Service Bulletin

Introduction of new power cords in the US

DX-D 100 / DX-D 100 Wireless

Title:	DX-D 100 - Service Bulletin No. 81 - New power cords available (US only)
Livelihood ID:	54386429
Version#:	9
Version Date:	2016-10-21 01:53 PM CET
Status:	Approved on 2016-10-27 12:21 PM CET
Owner:	Carsten Bockel (awyuq)
Created By:	Carsten Bockel (awyuq)
Created Date:	2016-04-12 11:15 AM CET
PDF Creation Date:	2016-10-27 12:21 PM CET

Figure 2 - Transition from straight to curled cable.

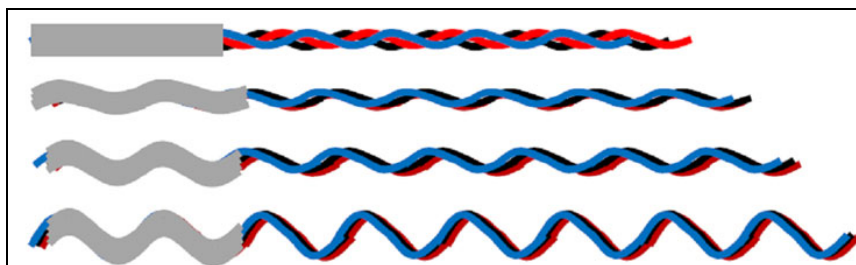
Symptom In some DX-D 100 / DX-D 100 wireless systems in the US the power cord is twisted and kinked during regular use. No issues with the functionality.

Cause The twisted wires in the power cord come loose and flatten out during regular use due to defect in the material. This creates the curled look. There is no influence on the functionality of the power cord.

Solution A revised power cord with optimized material is introduced as a spare part. Replace the power cord with the new power cord.
